Agenda Item Number: R 2-15

Re: Public Hearing - Repairs to the Thomas G. Walton Building

Walton Building Exterior Renovation - Minutes

Meeting Subject: Design Options Review

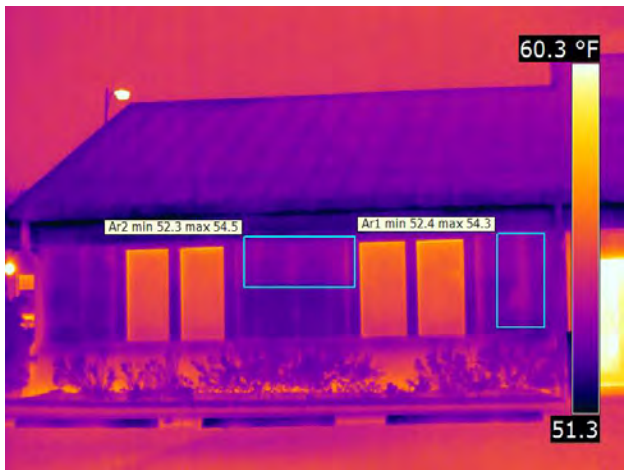
Location: east side of building. Image showing wet insulation inside walls.

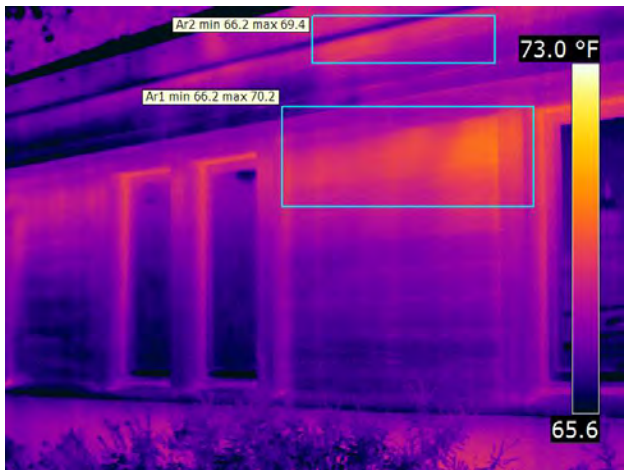
Location: east side of building. Image showing moisure where indicated. See page 2.

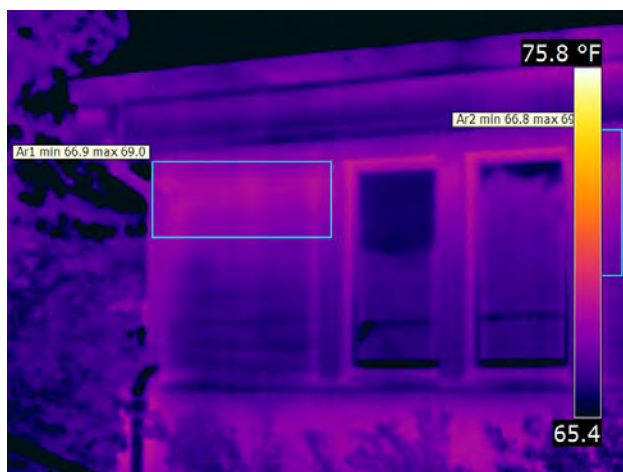
Location: east side of building. Image showing presence of moisture where indicated. See page 3.

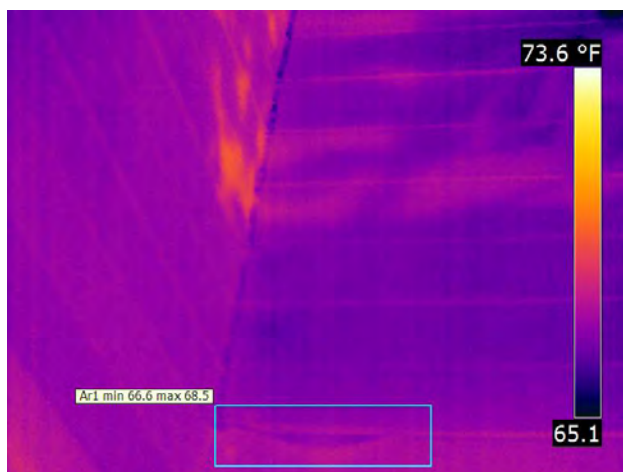
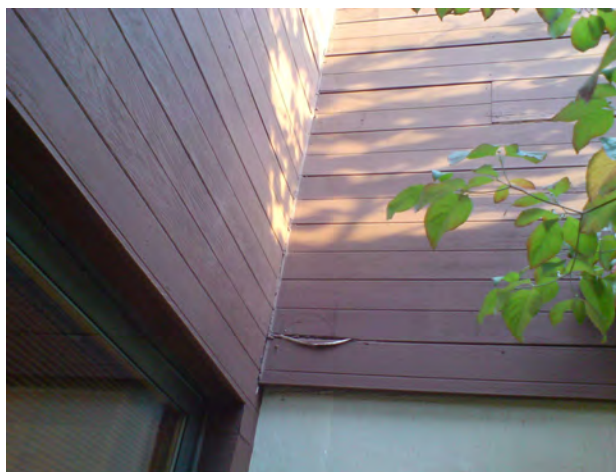
Location: east side of building. Caulking has deteriorated and allowing moisture to enter.

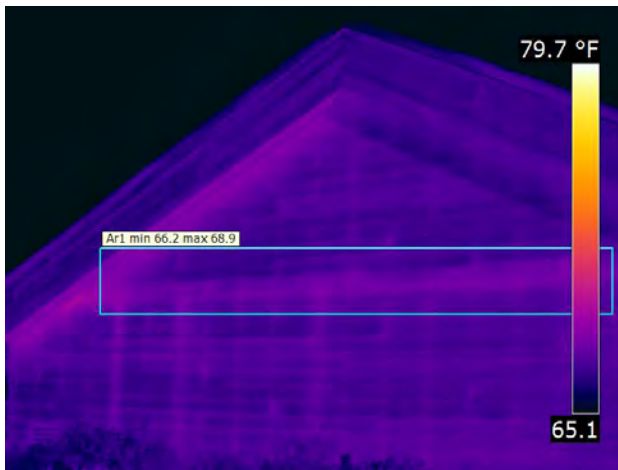
Location: south side of building. Image idicating moisture infiltration.

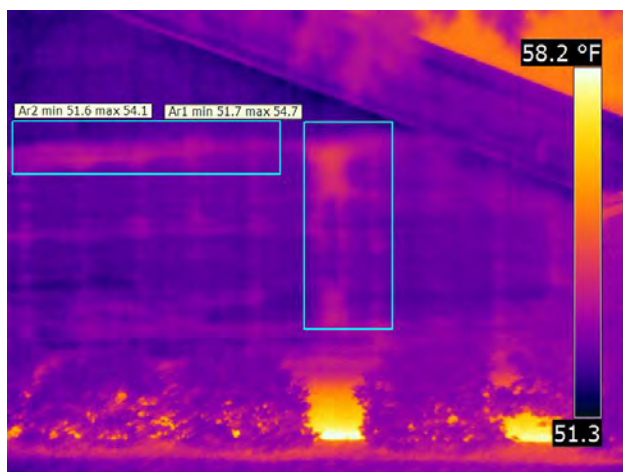
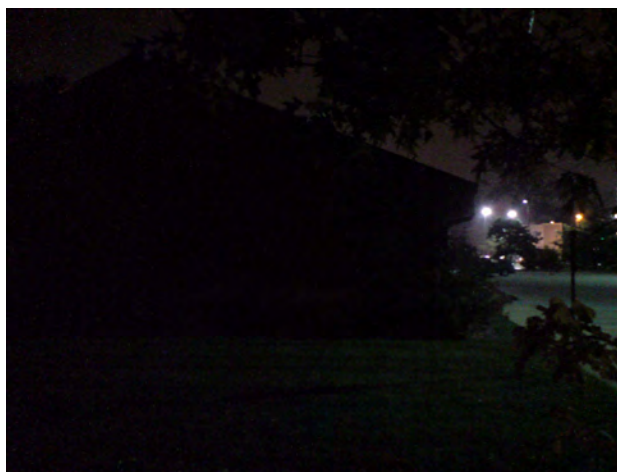
Location: south side of building. Image indicating areas of wet insulation.

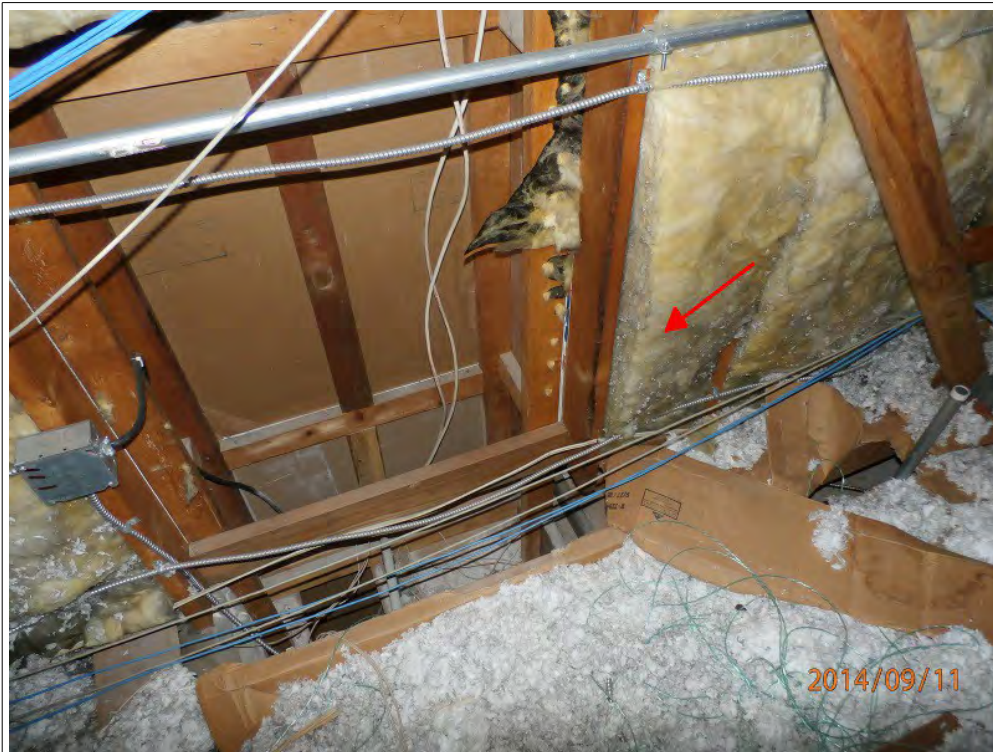
Attic insulation has been removed from walls around the central lobby causing energy loss and uncomfortable temperatures. Note black areas in fiberglass (arrow) which could be signs of excessive air movement (dirt accumulation) or possible mold growth. There is no air barrier in this area resulting in excessive infiltration. This area can function as a chimney, pumping out conditioned air.

Insulation has been walked down in many areas of the attic by repeated foot traffic. Permanent walk boards should be installed above the insulation level to allow IT wiring changes.

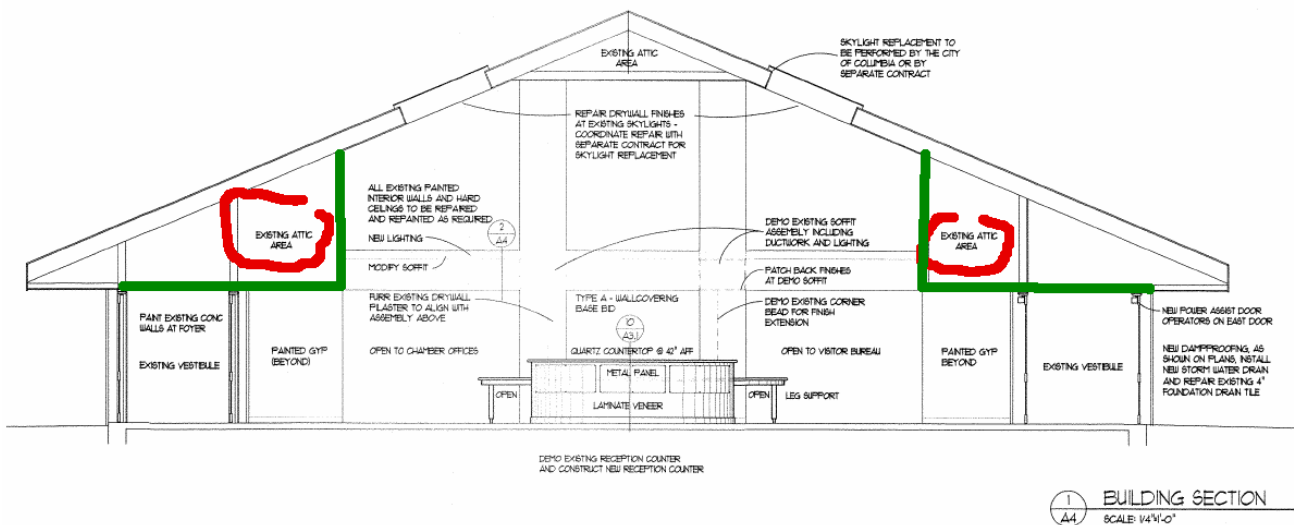
Evidence of water damage in the attic area behind the North wall. There was evidence of water damage inside the attic essentially everywhere we looked along all vertical outside walls. When exterior siding is replaced, weatherproof layers should extend to the eaves.

Polyethylene was used as a weather barrier in the attic, and has completely deteriorated. Cedar siding is visible, an ineffective weather barrier. Water stains show evidence of water penetration.

RECOMMENDED EXTERIOR WALL DETAIL

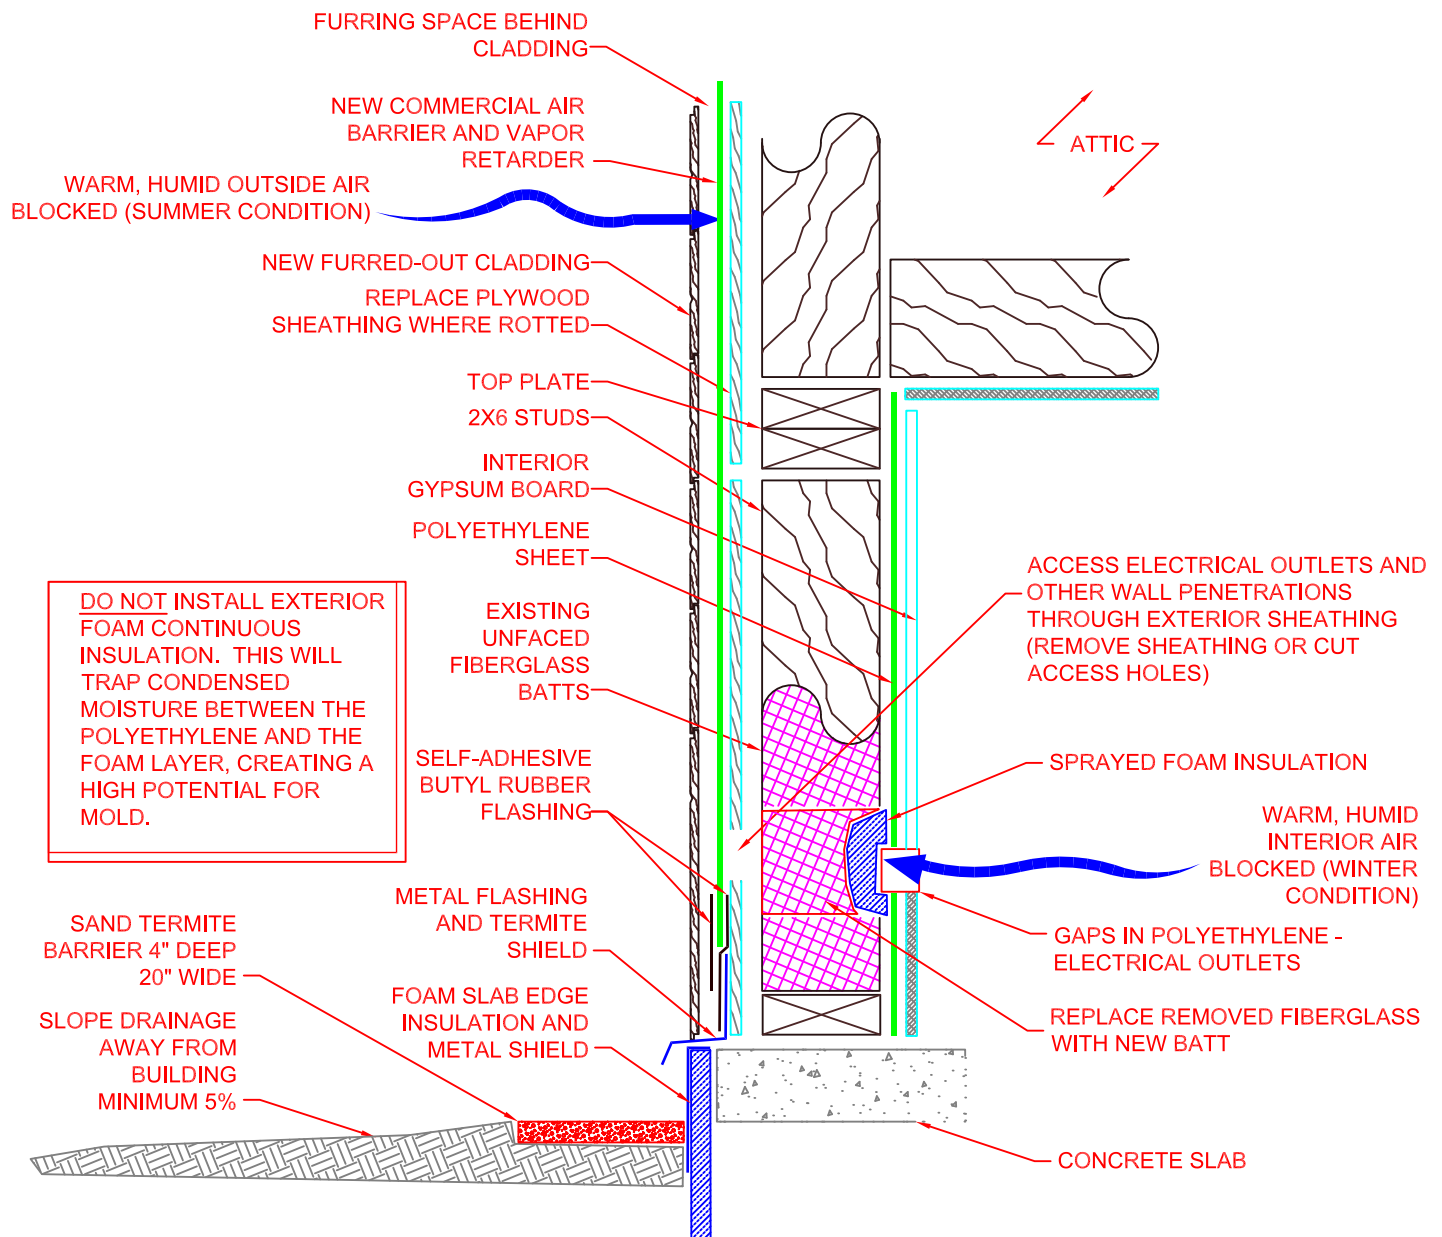
The exterior insulation is not recommended in order to add insulation value. Although it will have a minor effect on energy use, the important consideration is to control moisture. Exterior vapor-open continuous sheathing under a furred-out cladding is recommended to move dew points toward the outside of the wall and allow drying to the exterior. The major energy savings of this ECM is from reducing infiltration by air sealing.

1. Use the opportunity when replacing siding to inspect existing wall cavities. Remove sections of exterior plywood, push insulation aside and inspect the wall cavities for evidence of mold from past water entry, evidence of air leakage paths or rotted materials. Mitigate any mold that is observed.

2. Do not replace rotted plywood sheathing with OSB. OSB is made with glue that blocks moisture transmission and will trap moisture. Use real plywood to replace rotted sections of existing plywood sheathing. Use the opportunity to remove existing damaged siding and inspect the insulation cavity for evidence of mold and opportunity to spray foam insulation to reduce air infiltration. The principle here is to avoid introducing materials with a lower vapor transmittance than the existing materials. Such materials will increase the potential for mold formation.

6. Carefully detail the vapor retarder around windows, penetrations and the bottom edge, using self-adhesive butyl rubber flashing and metal edge flashings. Include a termite shield at the bottom of the wall. Tape seams and all edges to create a continuous barrier.
